Bulletin No.: 13365

FMVSS NONCOMPLIANCE RECALL

SUBJECT: Fuel Label Compliance

MODELS: 2013-2014 Chevrolet Express, Silverado HD

Chevrolet Express/GMC Savana Label Installation Instructions

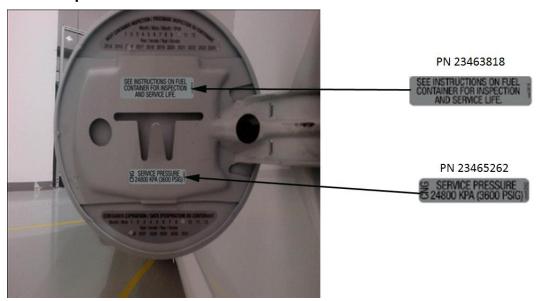
General Motors has decided that certain 2013 model year GMC Savana, and 2013 and 2014 model year Chevrolet Express, Silverado HD, and GMC Sierra HD compressed natural gas vehicles fail to conform to Federal Motor Vehicle Safety Standard 303 for label text size. The text of the fuel label that is installed on the inside of the fuel door is not to the specified size and may be less noticeable.

Dealers are to remove the label on the inside of the fuel door and install two new labels that contain larger print.

- Remove existing label and any residue using isopropyl alcohol. Dry the label surface with clean, lint free cloth. The label surface must be clean, dry and free of any contaminants. Do NOT place new label over an existing label.
- 2. Firmly hold the new label and peel protective liner from the back side, being careful not to touch or contaminate the adhesive with dirt or foreign matter.
- Carefully align new label to the surface press firmly and smooth out entire label ensuring corners are fully adhered.
